Project Memorandum

To Laura Oliver, Deputy Recorder
From Shay Stark, Contract City Planner *JS*
Date October 30, 2019
CC
Subject C & L Estates Subdivision Preliminary Plan – Planning Commission Memo

C & L ESTATES SUBDIVISION
PRELIMINARY PLAN
SUPPORTING DOCUMENTATION

Preliminary Plan Second Submittal Review Comments.

4B

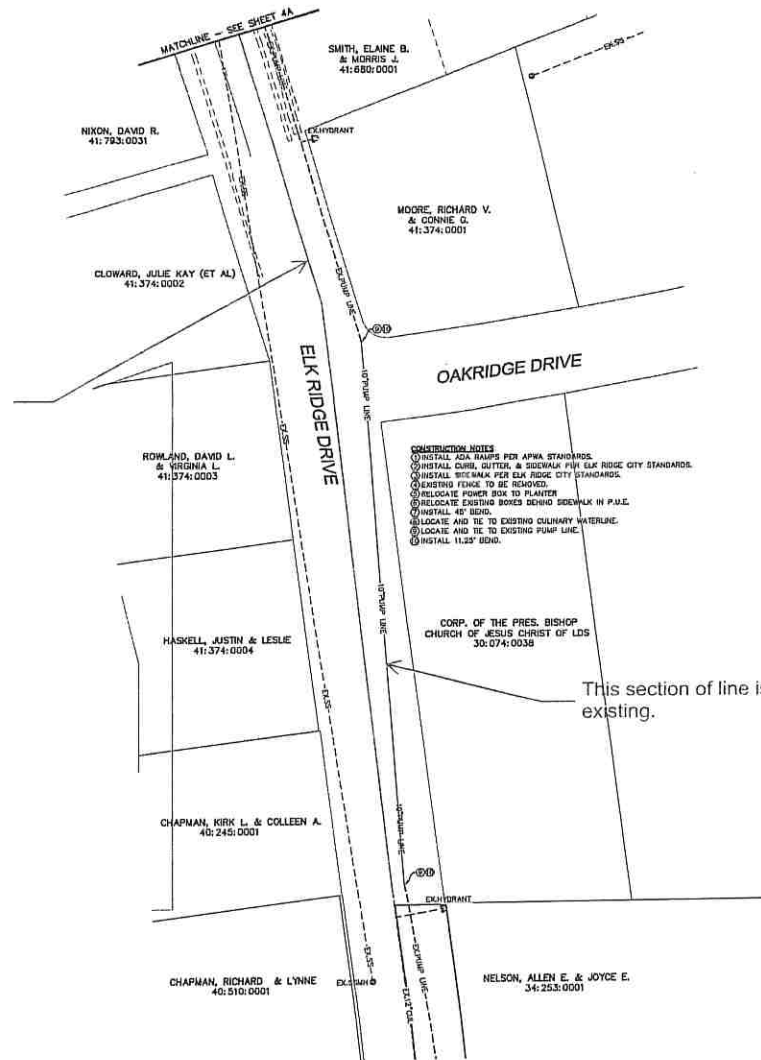
New 12" distribution line to be paid for by the City. The new line would also include relocation of the remaining services off the existing pump line to the new line and relocation of fire hydrants off the pump line to the new line. The services and hydrants requiring relocation need to be determined by the City. There may be services on Elk Ridge Drive and Gooseneck Drive that require relocation.

DETAIL - TYPICAL 66' ELK RIDGE DRIVE RIGHT-OF-WAY STREET SECTION
-NTS-

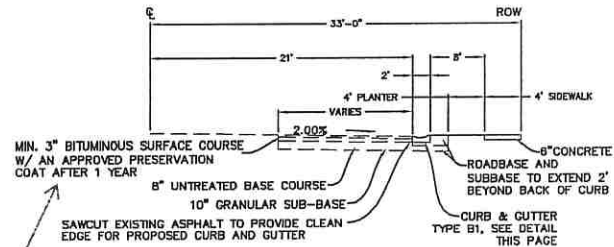
The City requires a 1" surface course overlay from crown to gutter on existing boundary streets where cuts and patches or additional pavement width are required. With the potential resurfacing of Elk Ridge Drive this will need to be discussed as construction drawings are created.

6

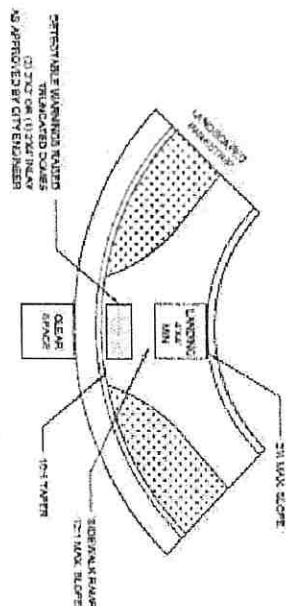
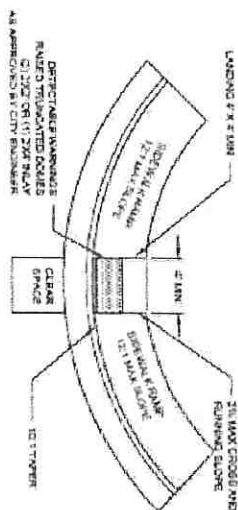
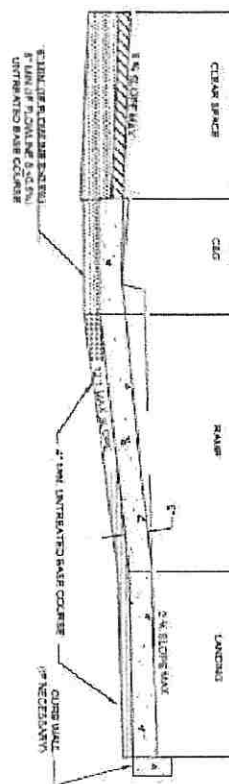
The details on this sheet don't print out very clear.

The applicable State approved City standard water details will be required as part of the construction drawing package.
